CREDWELL

Project	Bondi Surf Bathers Life Saving Club
Report	Access Assessment Report (DA Stage)
Reference	C19506-Access-r2
Date	19 April 2021
Client	Lockhart-Krause Architects
Contact	Jesse Lockhart-Krause jesse@lockhartkrause.com.au

5.2 Access to buildings - NCC Clause D3.2

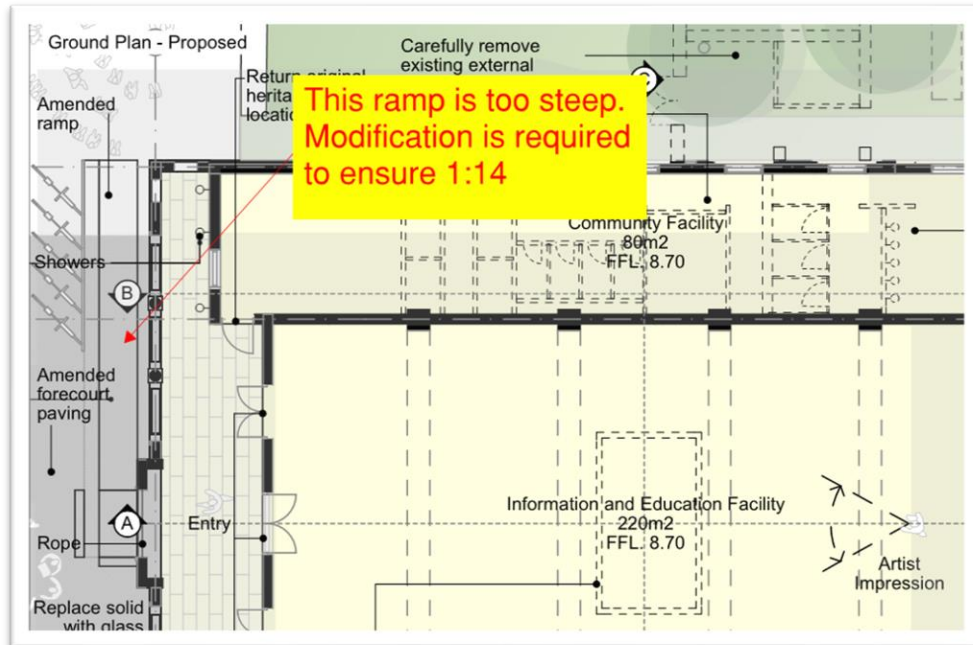
Wheelchair access into the ground floor of the public hall is via the existing external pedestrian pathways that bound the building that connect to the existing pedestrian ramp at the building

frontage. The existing ramp then leads occupants through existing double doors and into the surf museum/public hall.

The existing ramp that is part of the “affected part” path of travel (see part 3.2 of this report) has a gradient of 1:11 which is technically non-compliant. Under AS1428.1-2009 the gradient of the ramp must be 1:14.

As advised this ramp will be modified to ensure compliance with AS1428.1-2009 is achieved.

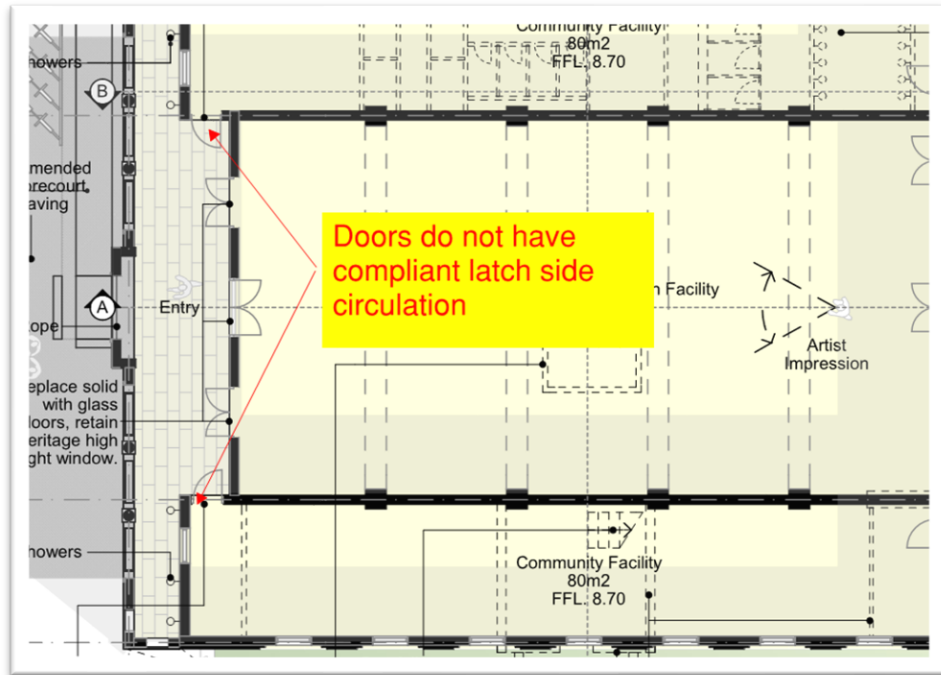
1. At the ground floor the existing main entrance doorways serving the men's and women's changerooms are not provided with sufficient clear latch width to ensure compliant wheelchair doorway circulation as required under AS1428.1-2009. In rectifying this item at a later stage of development a performance solution will be undertaken to justify the installation of power-operated doorways.

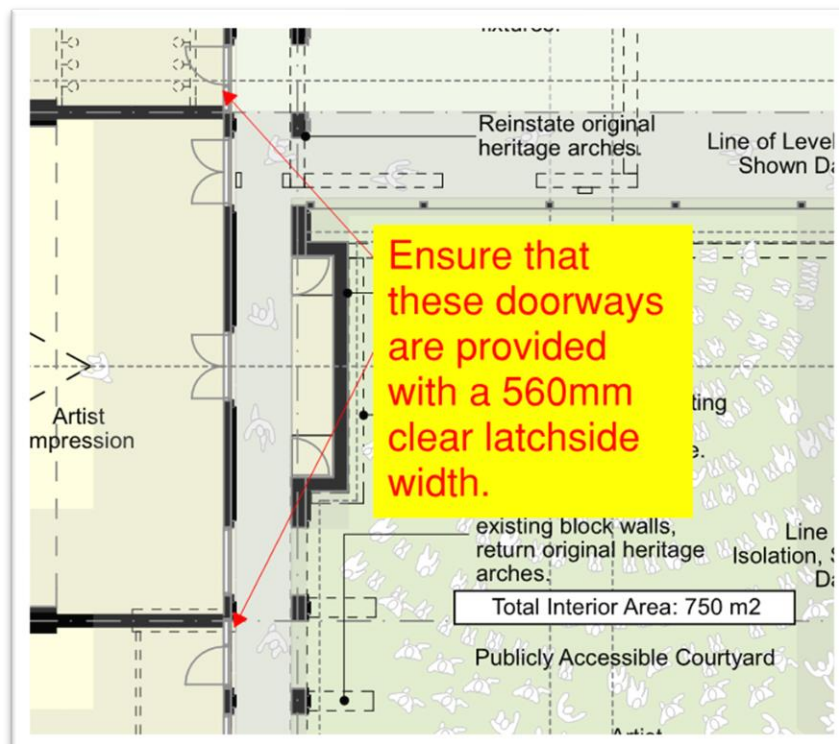
2. Within the ground floor the doorways that open from the rear of the community facilities to the publicly accessible courtyard area are not provided with sufficient clear latchside to ensure compliant wheelchair doorway circulation as required under AS1428.1-2009. Please show on updated plans these latchside achieving a minimum width of 560mm.
